SITE SUPPLEMENTAL INSTRUCTION

PROJECT: Forestside Estates
Attmar & Palleschi Drive
Brampton, ON

SITE SI NO. M-7

PURPOSE: To revise make-up air risers to suit space requirements & City Permits comments.

DRAWN	CHECKED	SCALE
MC	LM	1:50
DATE	PROJECT	DRAWING
MAY, 2019	18-017	M-21A
		OF

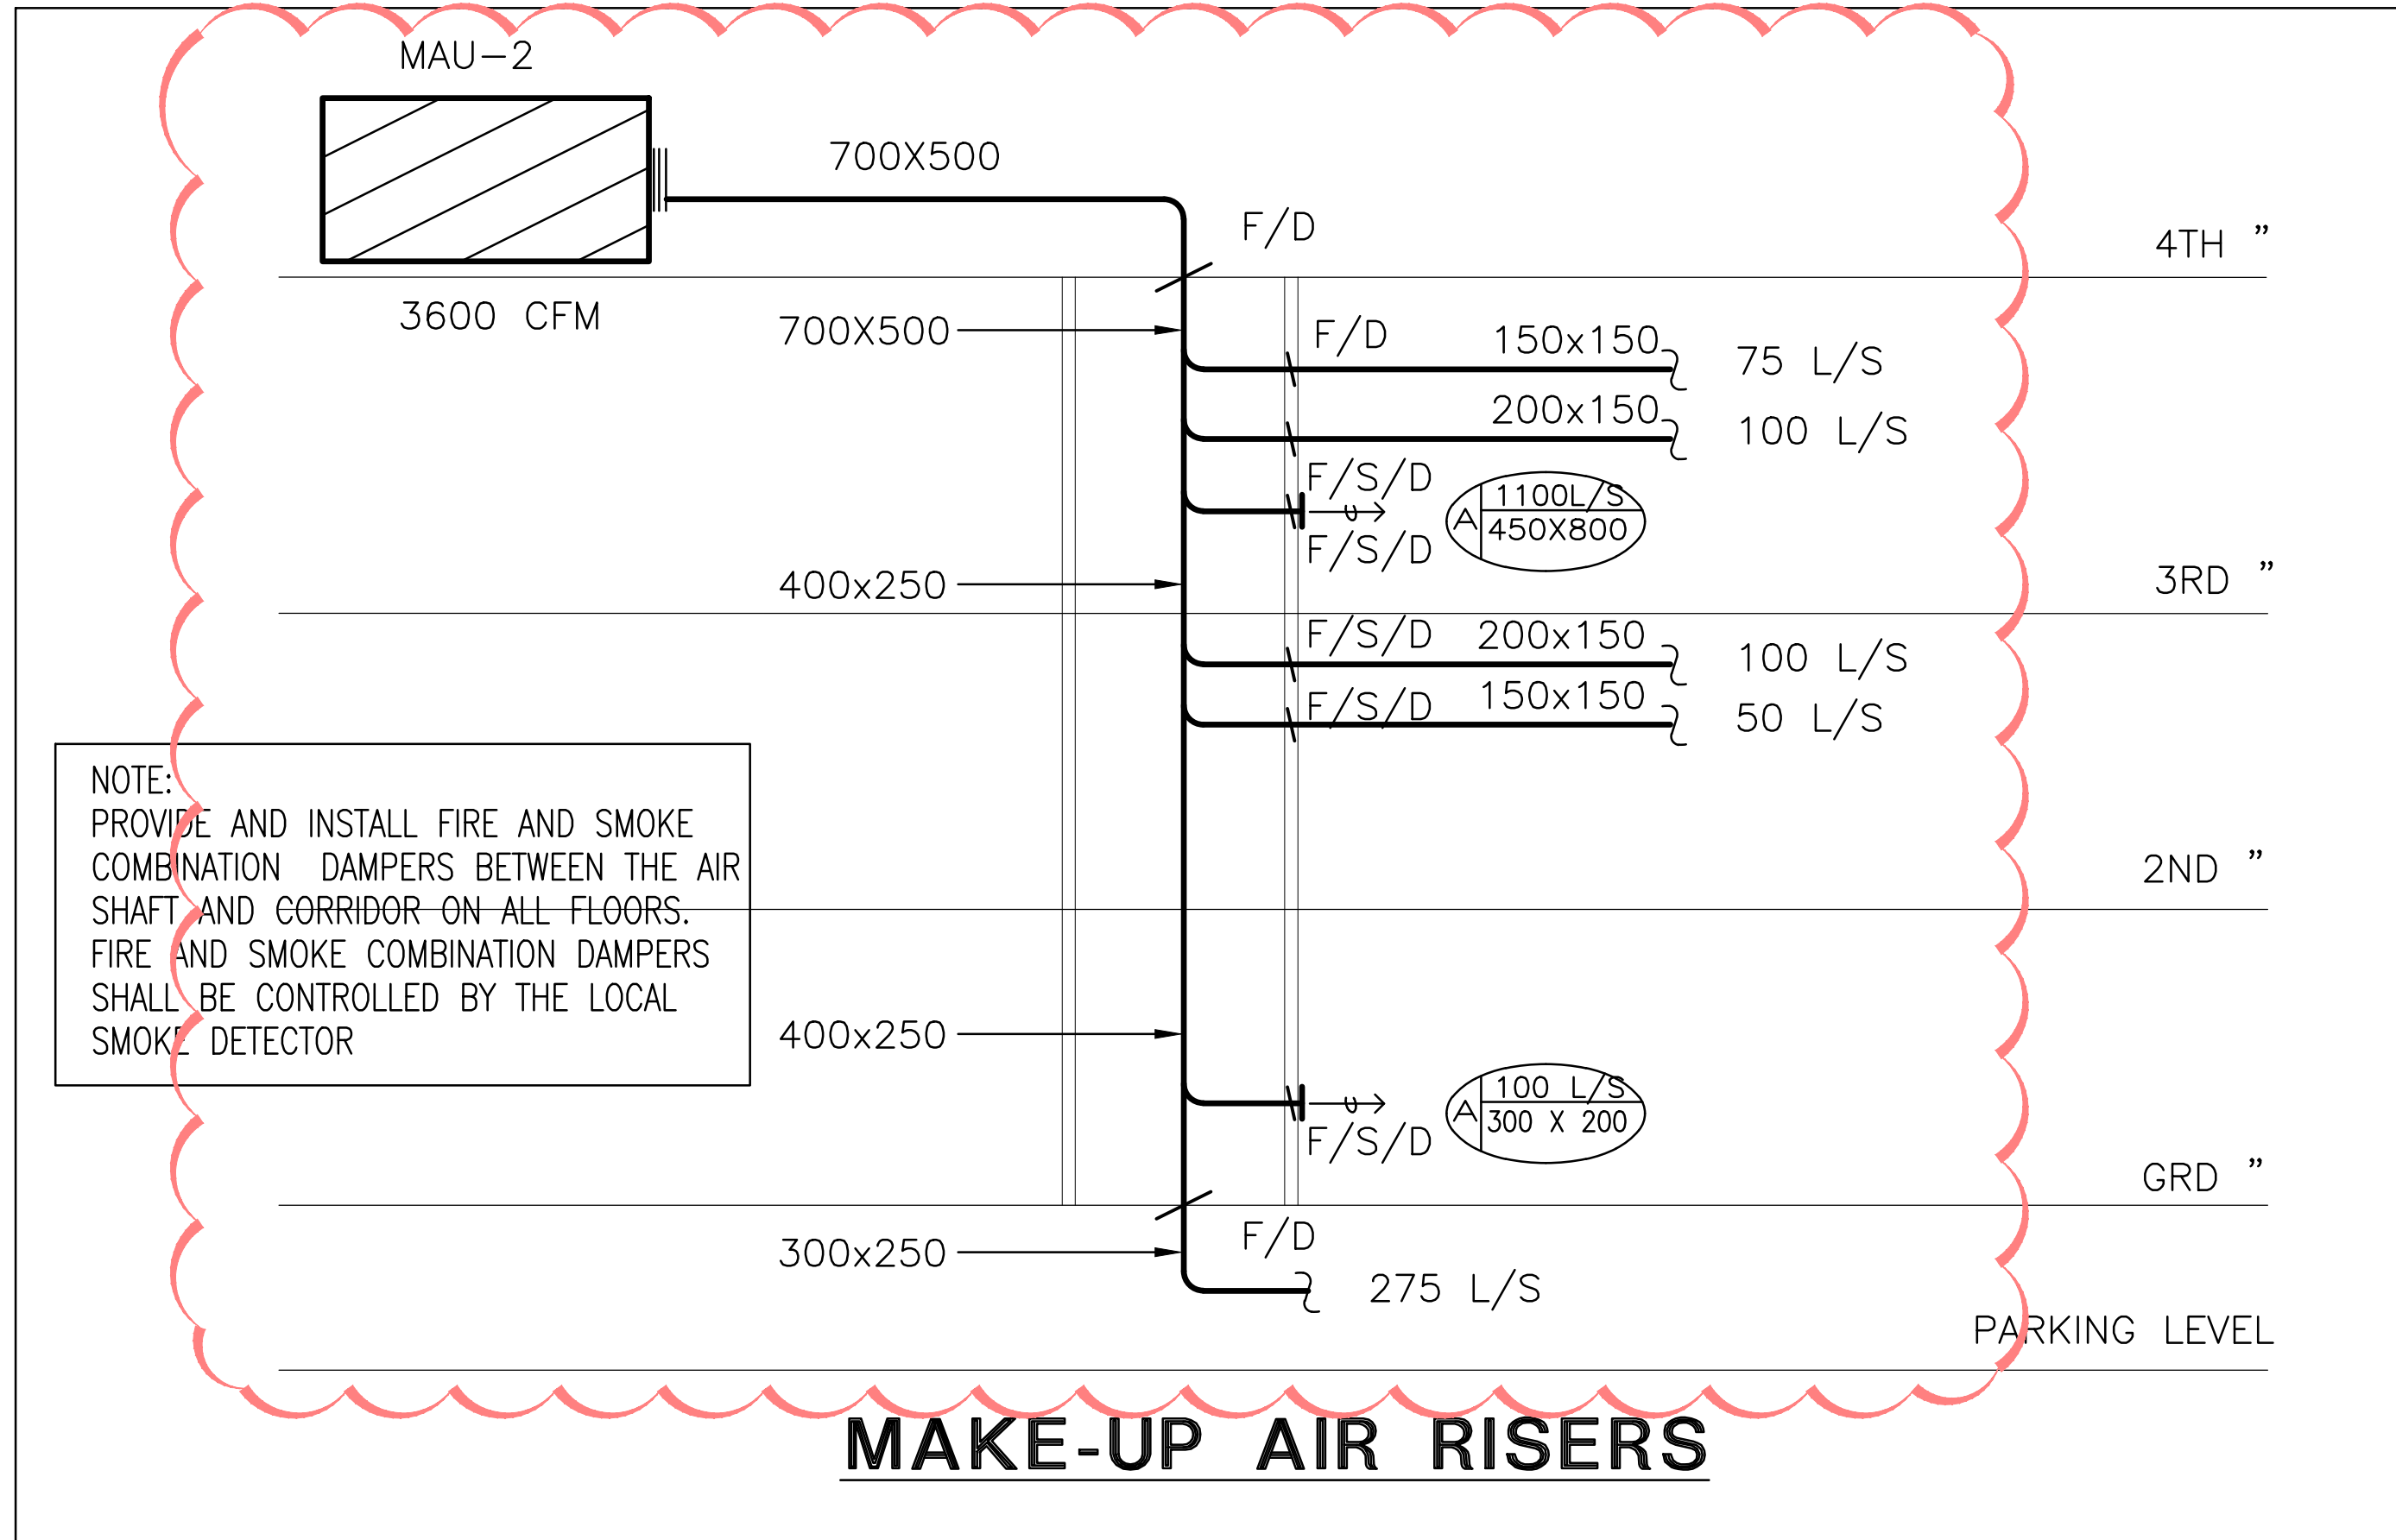
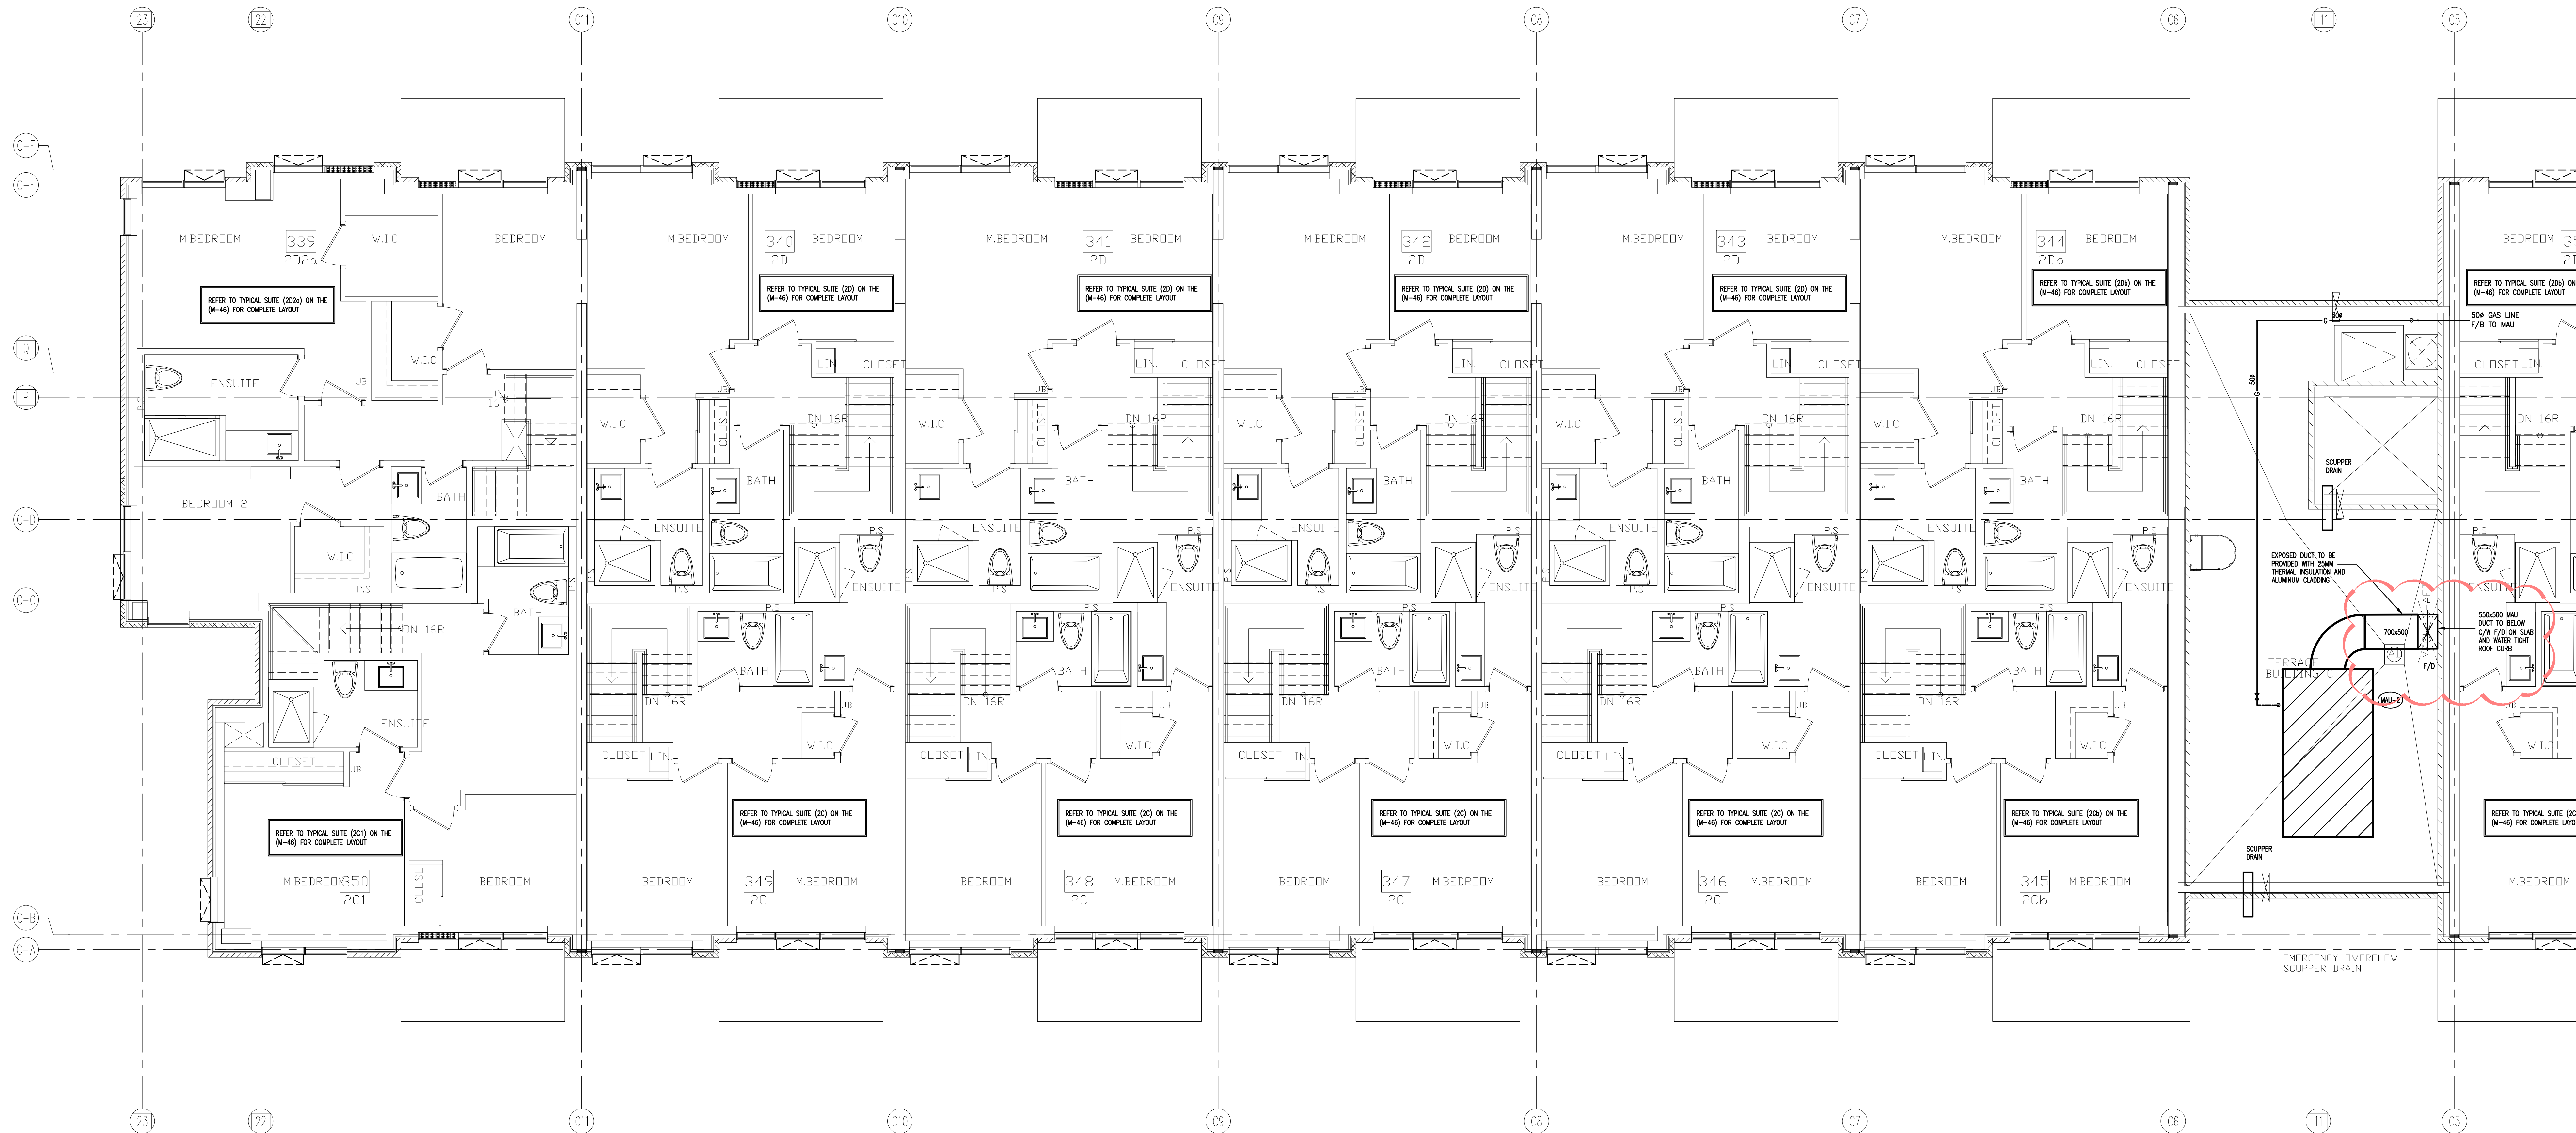
9.1 Clarify: Make-up air duct size.

9.2 Revise: Make-up air riser diagrams.

DRAWN MC	CHECKED LM	SCALE 1:50
DATE MAY, 2019	PROJECT 18-017	DRAWING M-25A OF -

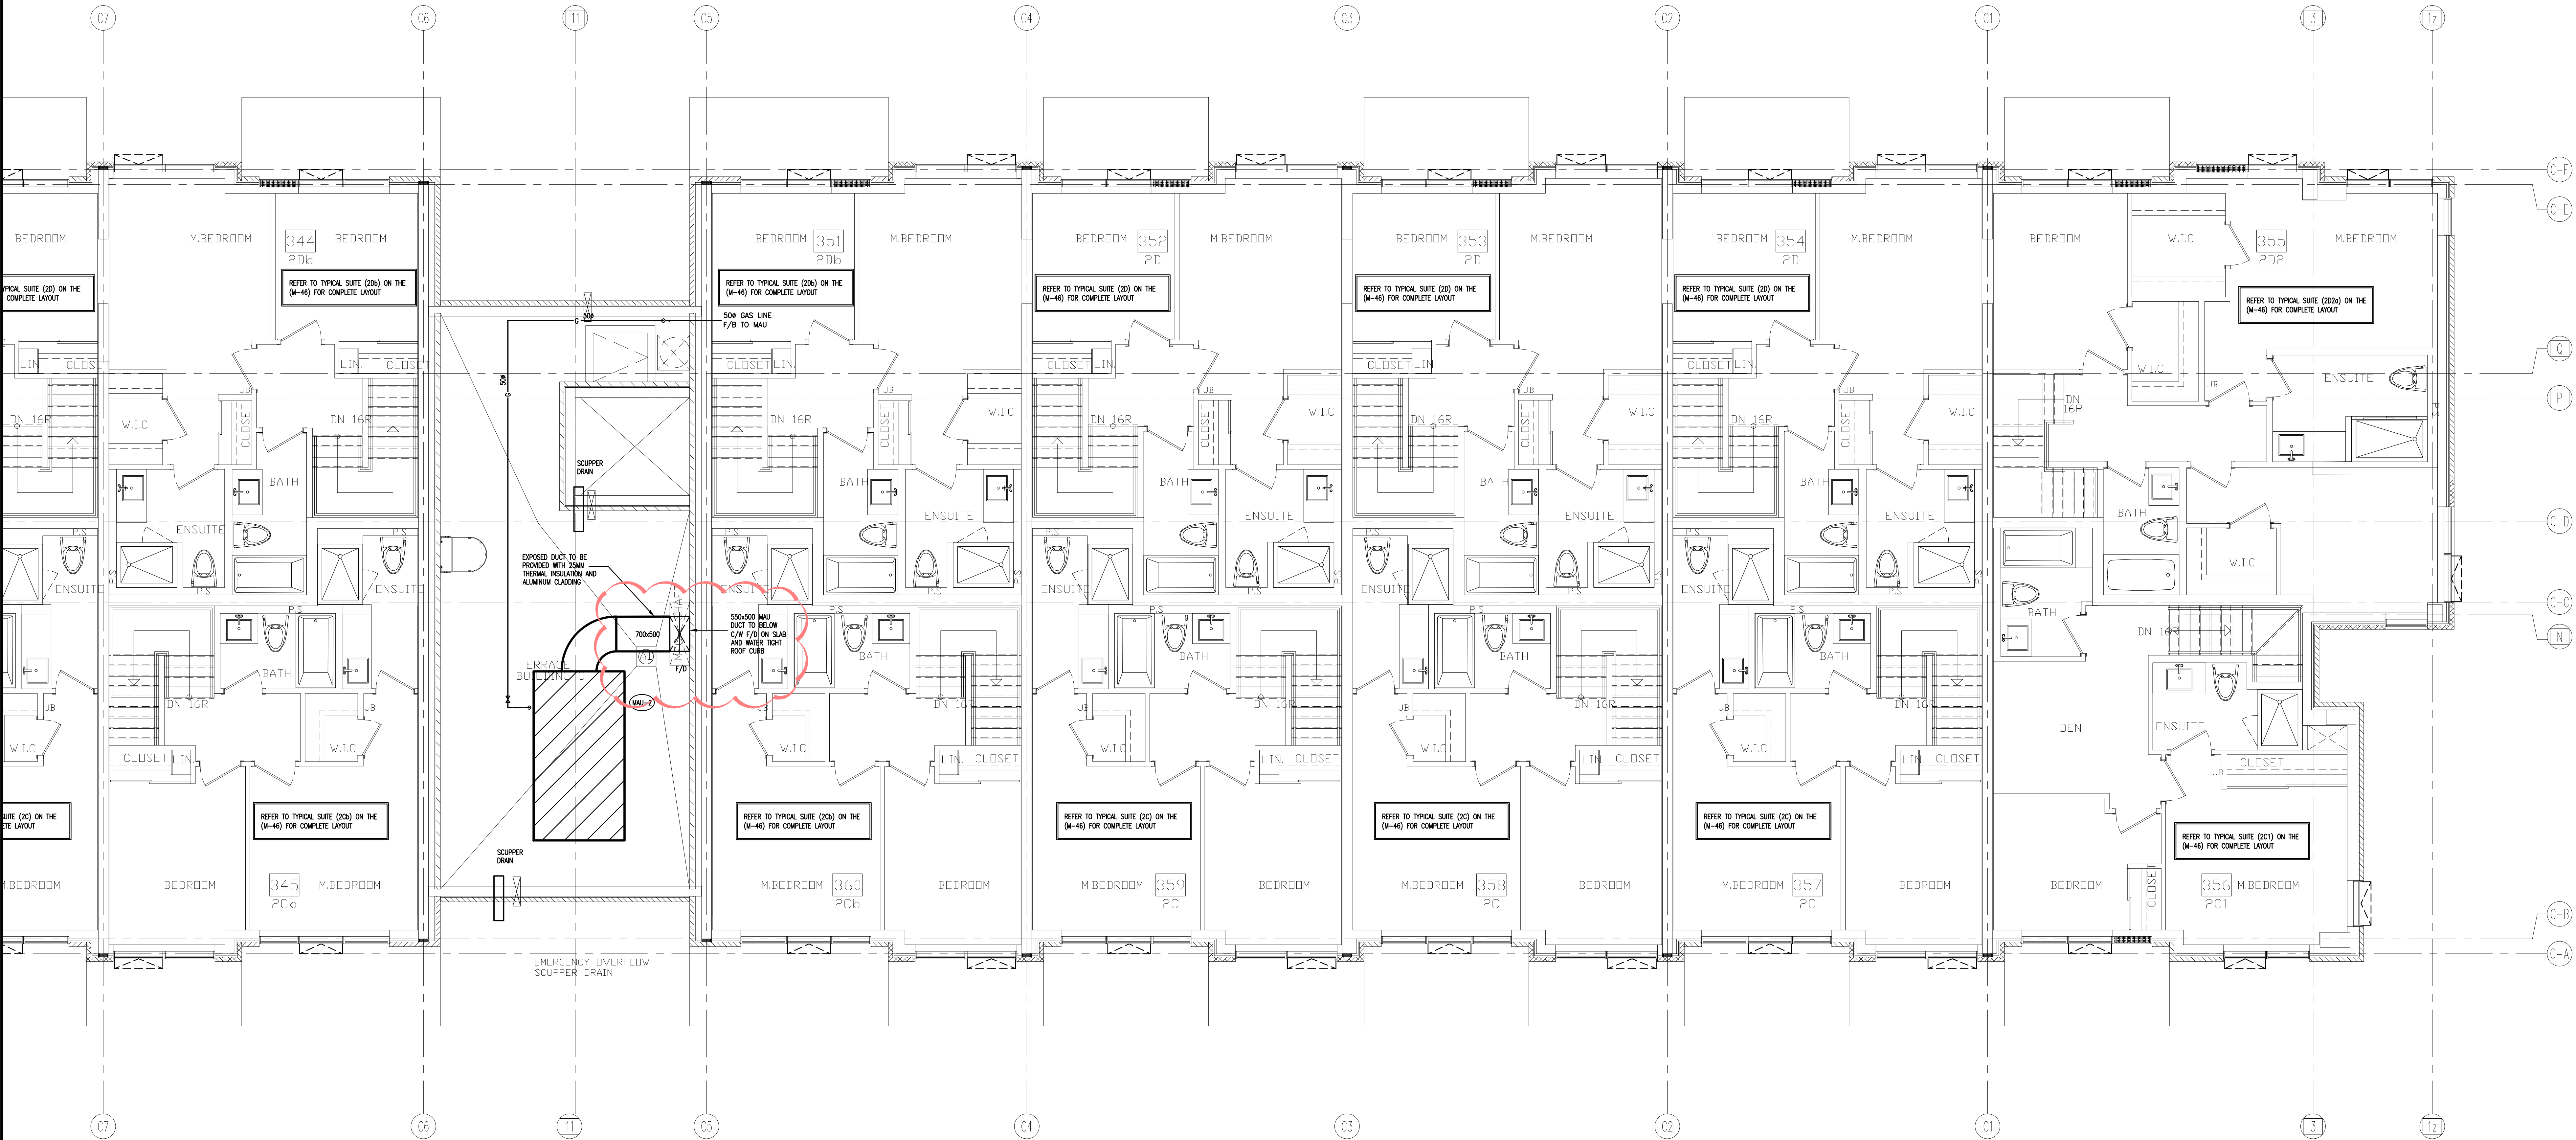
10.1 Clarify: Make-up air riser.
